## NOTICE OF HEARING BOARD MEETING LOWER TRENT CONSERVATION

O. Reg. 41/24 Permit Application #RP-24-232

## STAFF REPORT

**Date:** February 28, 2025  
**To:** Lower Trent Conservation Hearing Board  
**Re:** Ontario Regulation 41/24 application for permission RP-24-232 to develop within the Butler and Arena Creek floodplain and within 30-metres from a wetland feature  
**Prepared by:** Gage Comeau, Manager, Watershed Management, Planning and Regulations

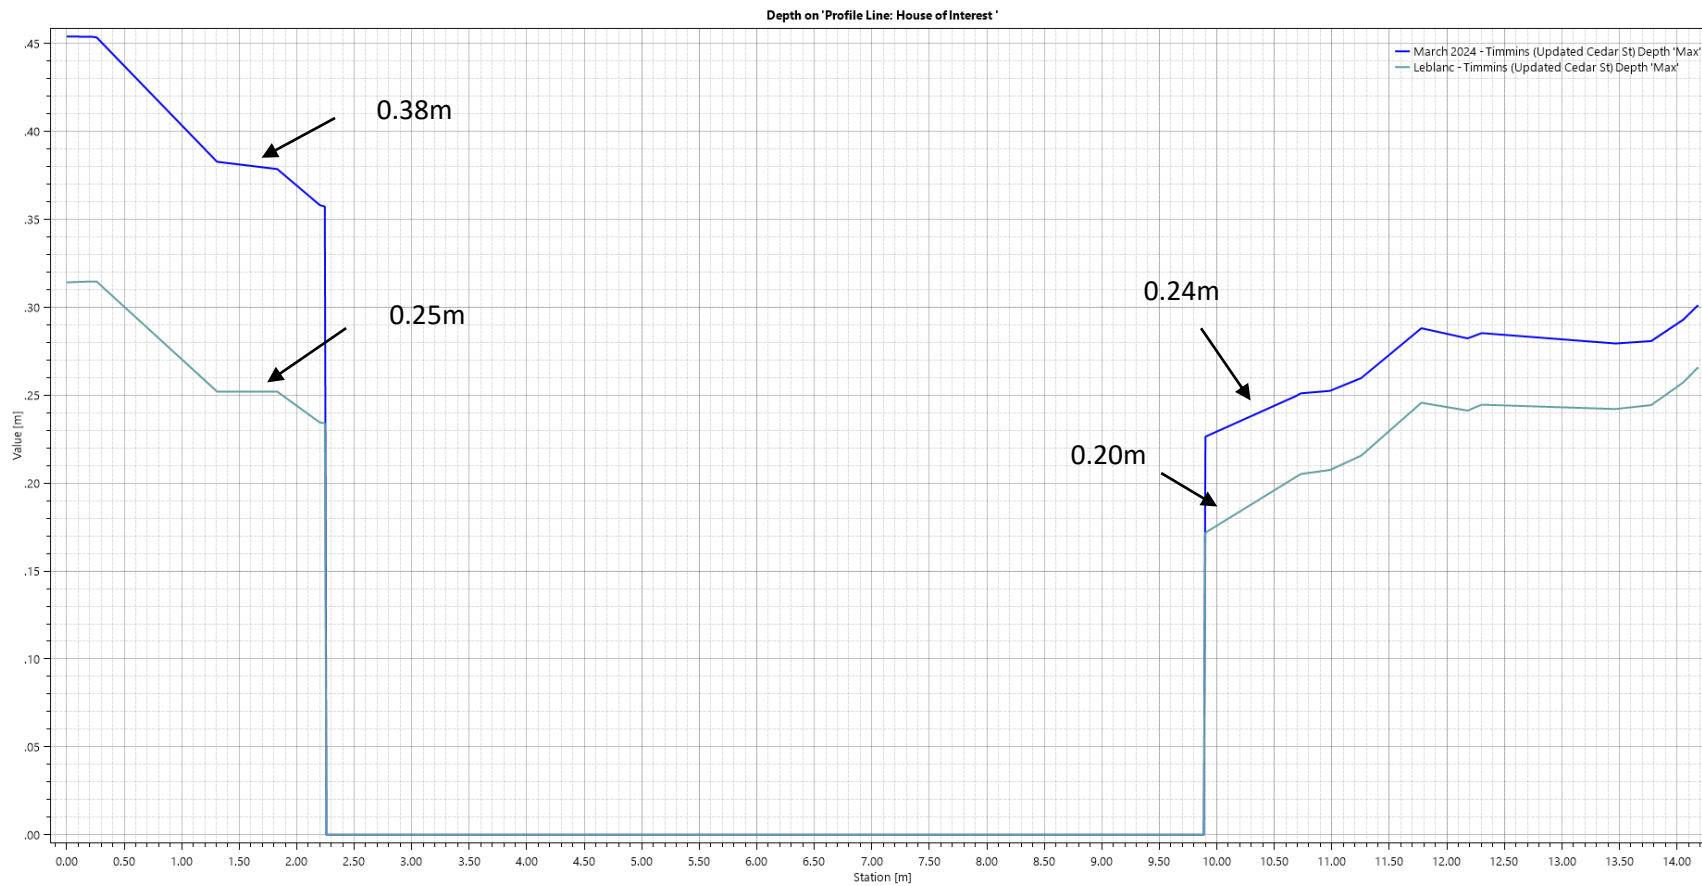
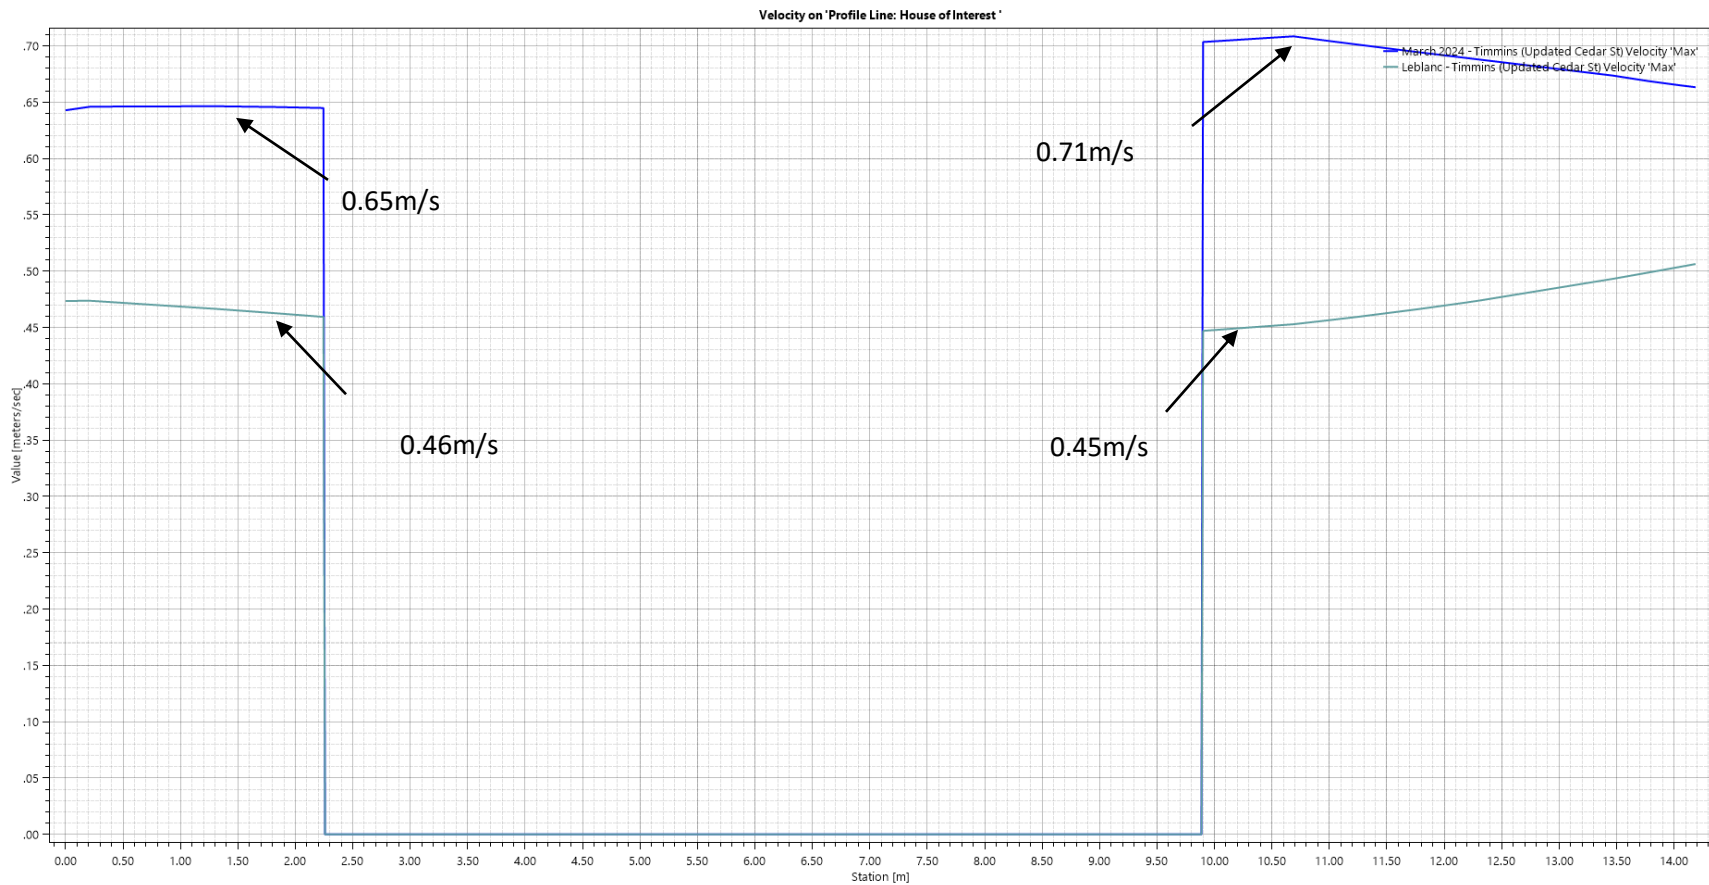
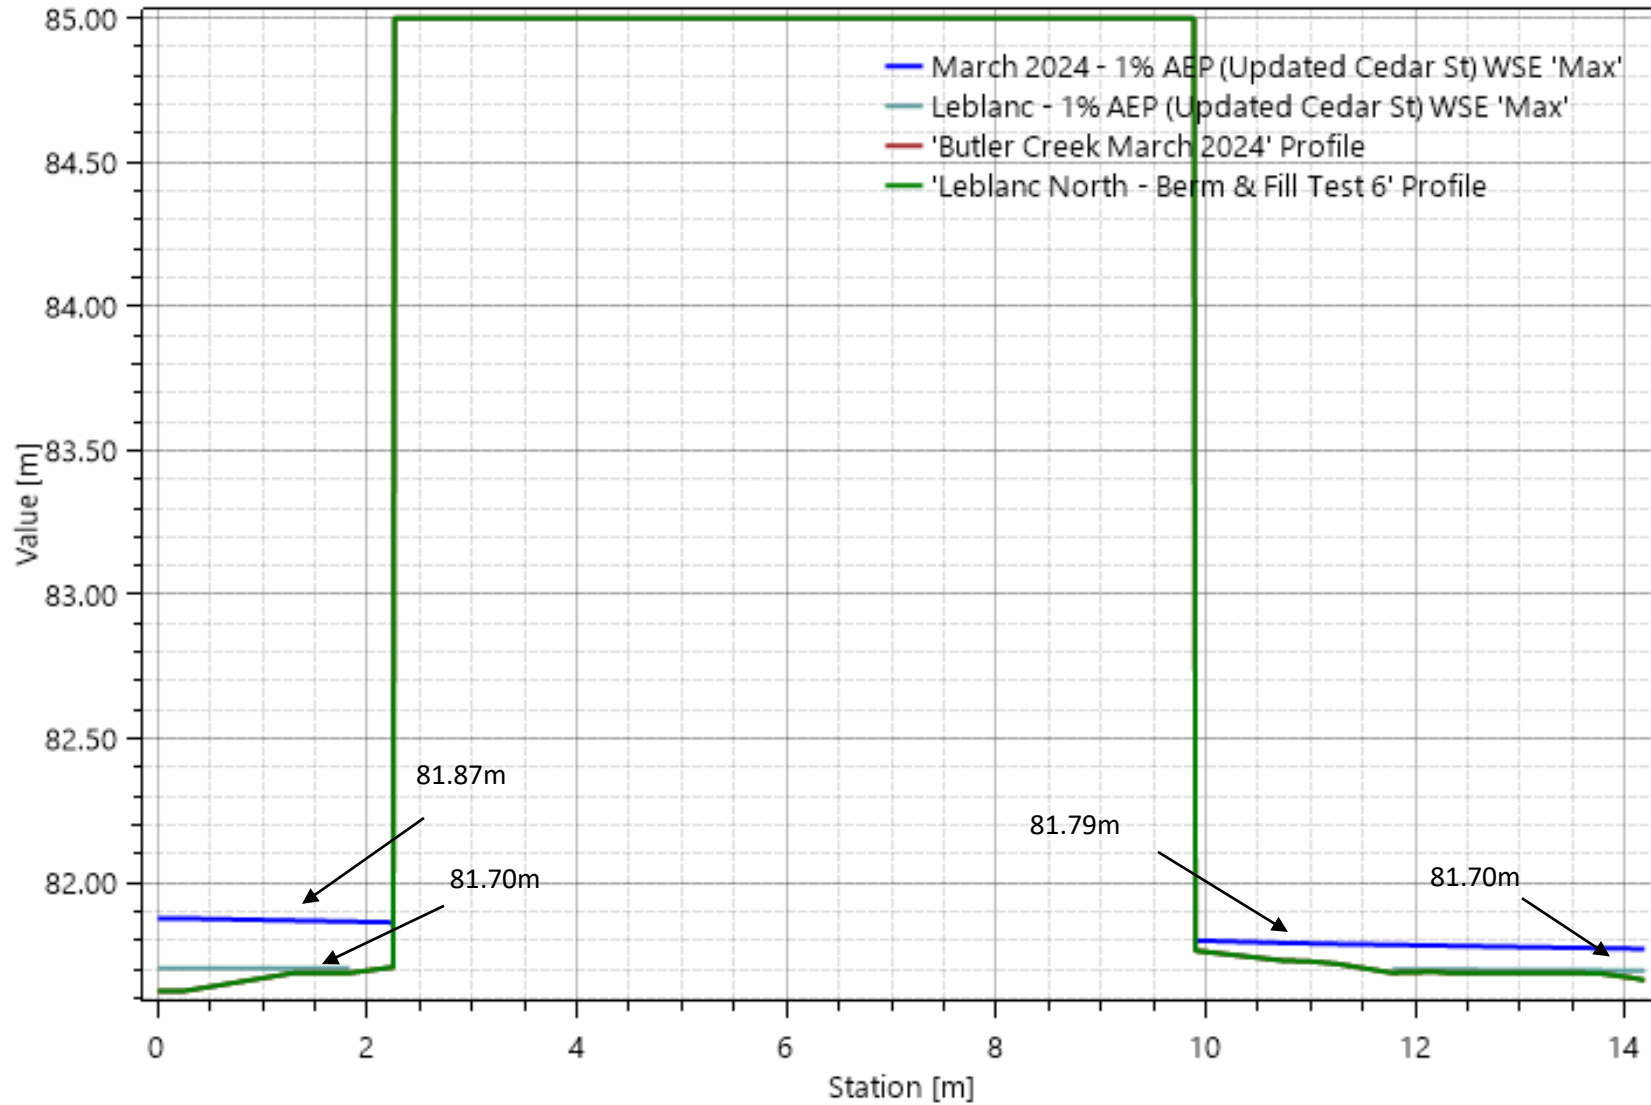
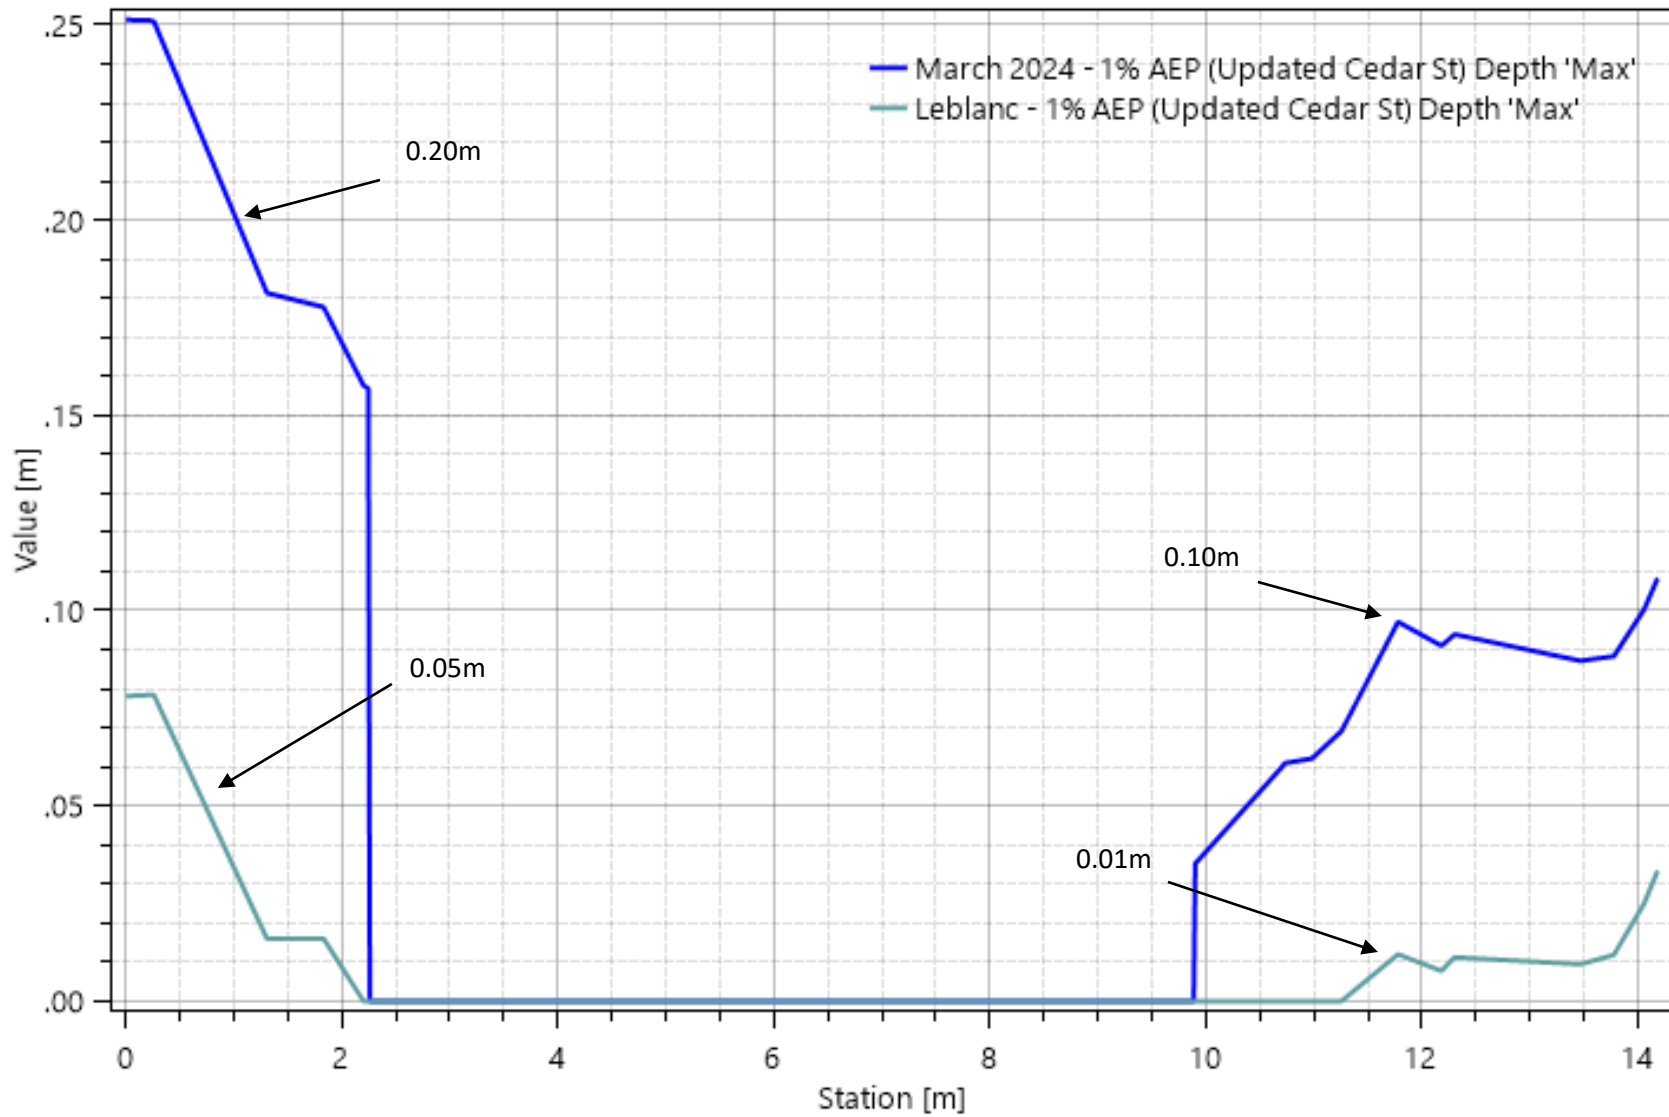
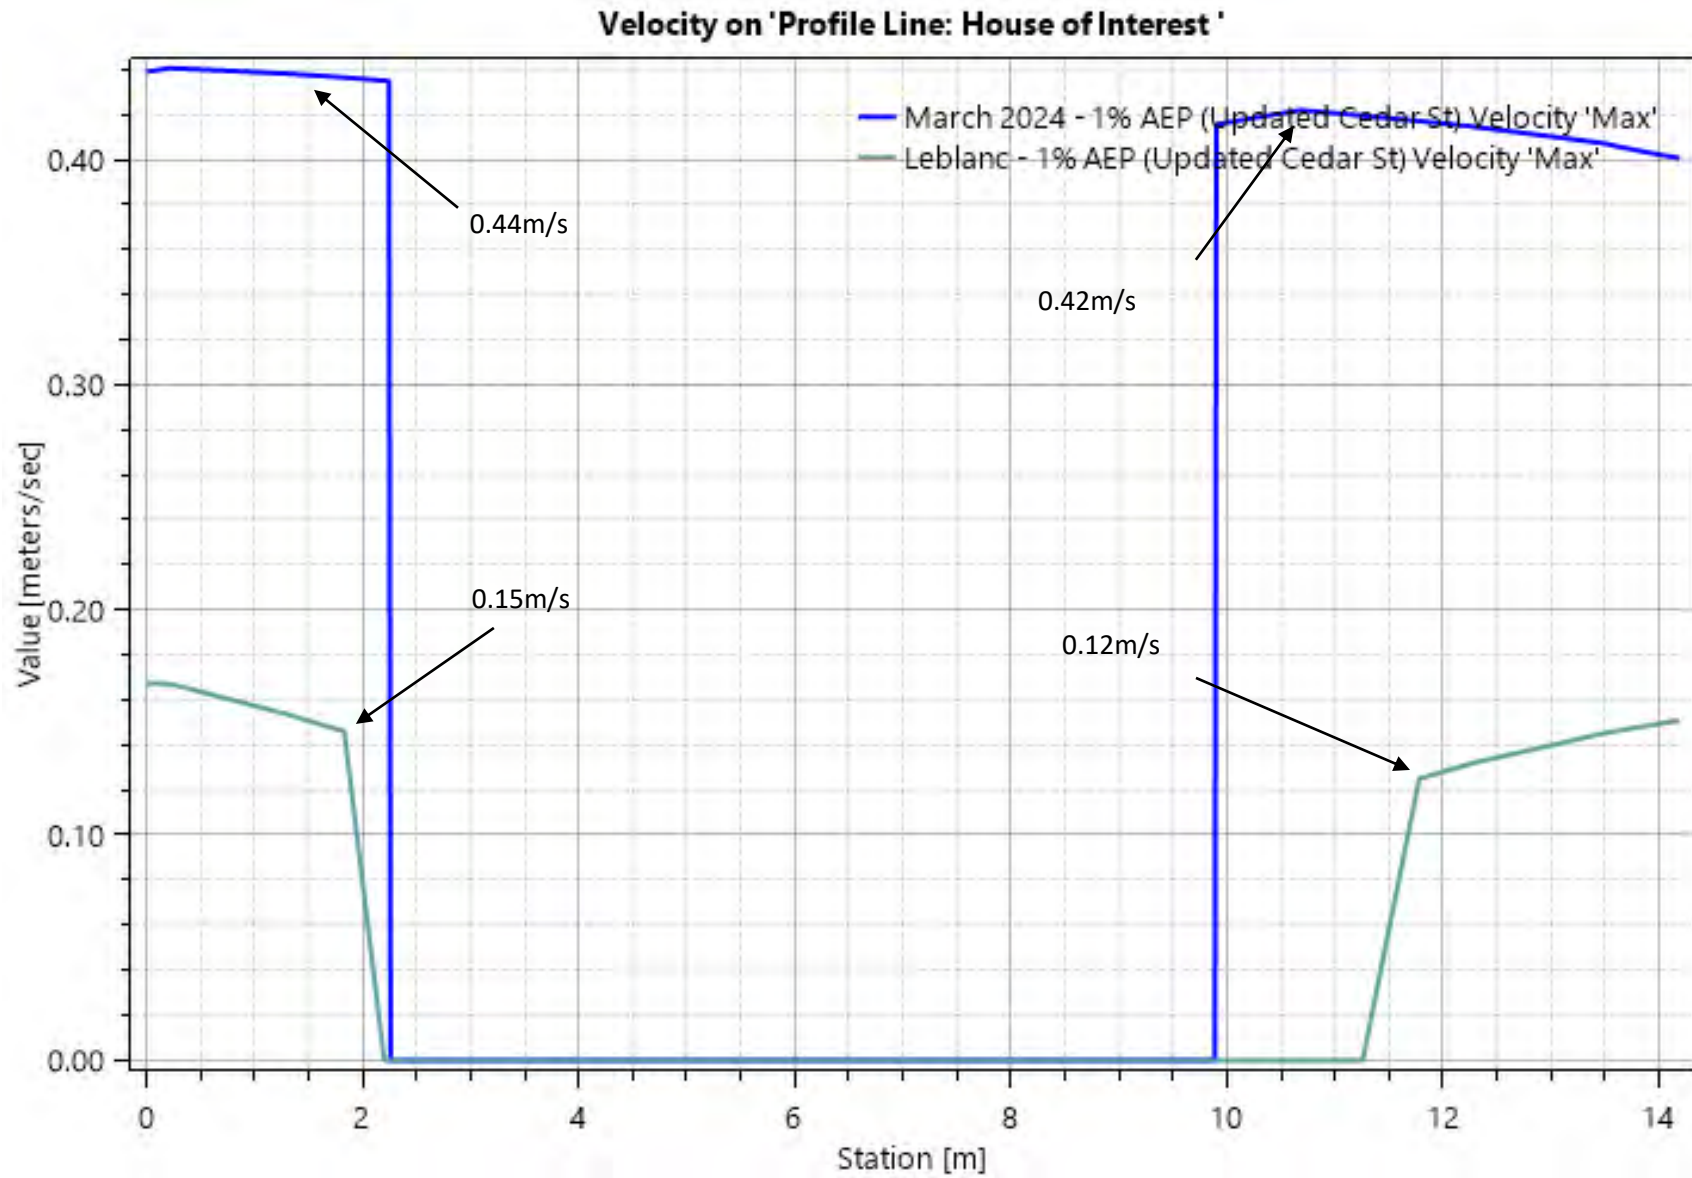
<b>Request #1:</b>	<p>The depth and velocity information before and after the flood mitigation plan at the house immediately upstream of Cedar Street.</p> <p>An assessment of smaller return period events was noted to be useful to confirm whether the house is negatively affected in events less than the regulatory storm.</p>
